OYSTER CREEK NUCLEAR GENERATING STATION, UNIT NO. 1

AMENDMENT TO PROVISIONAL OPERATING LICENSE

Amendment No. 46  
License No. DPR-16

ATTACHMENT TO LICENSE AMENDMENT NO. 46  
PROVISIONAL OPERATING LICENSE NO. DPR-16  
DOCKET NO. 50-219

FIGURE 3.5-1

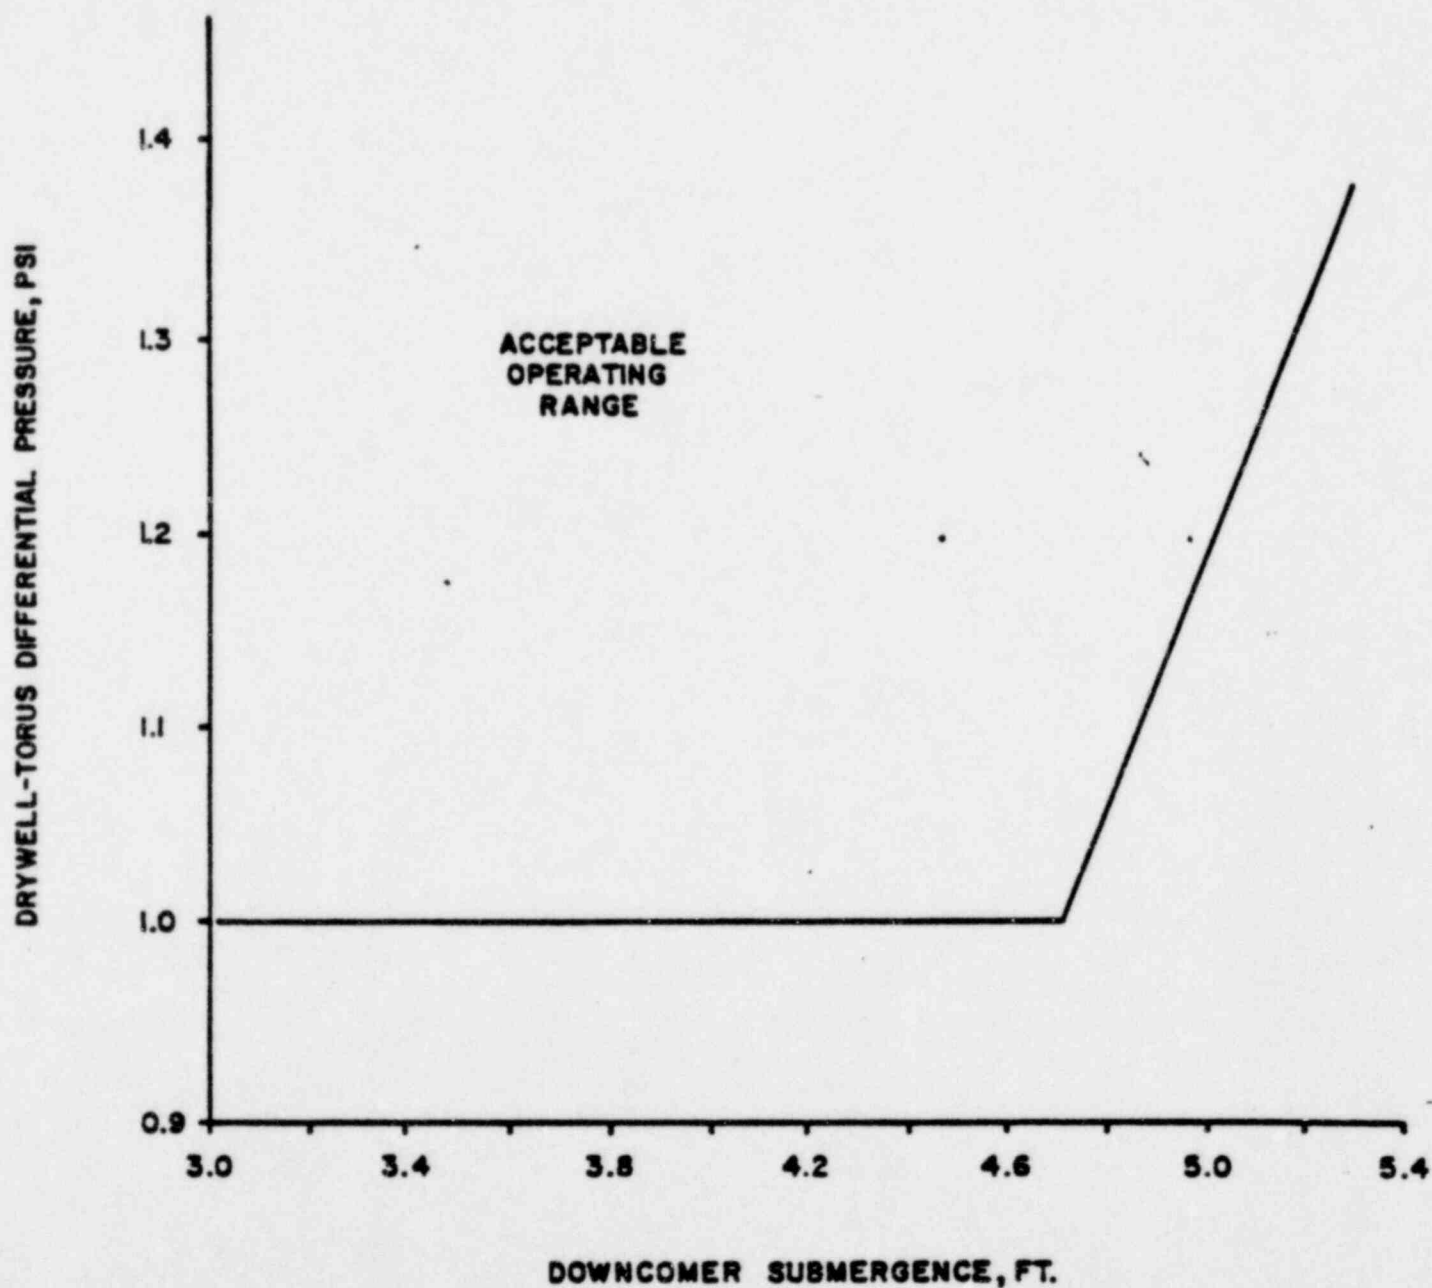
Replace the following pages of the Appendix "A" Technical Specifications with the enclosed pages. The revised pages are identified by the captioned amendment number and contain vertical lines indicating the area of change.

\*The actual acceptable range of downcomer submergence is governed by the Technical Specifications limit on maximum and minimum water volume in the torus (see section 3.5.A.1). This actual acceptable range of downcomer submergence will not encompass the full range of downcomer submergence indicated in the figure above.
